From: [REDACTED]
Sent: 08 June 2026 17:18
To: Kate Parry
Cc: [REDACTED]
Subject: Re: P2026/0224 - Land To Rear Of 9 Maes Llwynonn Cadoxton Neath Port Talbot SA10 8AQ

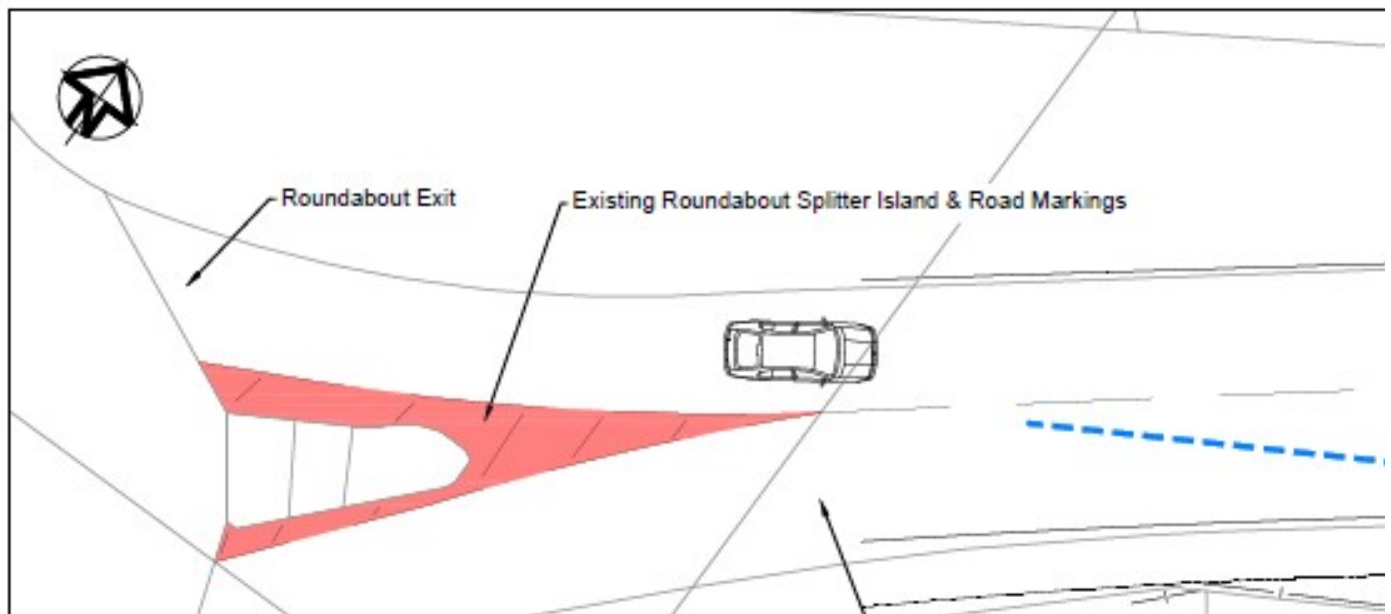
Please find our annotated plan on the images below.

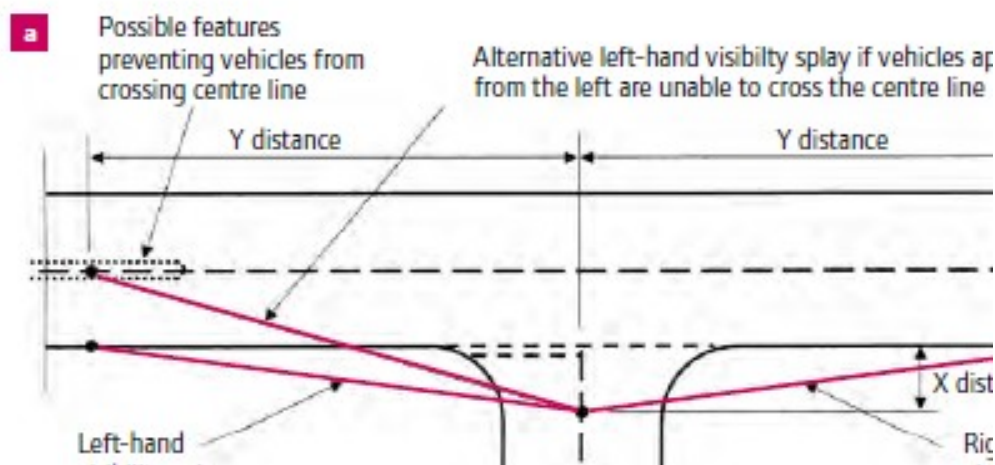
Please also see below an abstract from Manual For Streets - Figure 7.18 Measurement of junction visibility splays on a straight road. As seen on the image below the splay can only be shown to the centre line, where there are features preventing vehicles from crossing the centreline.
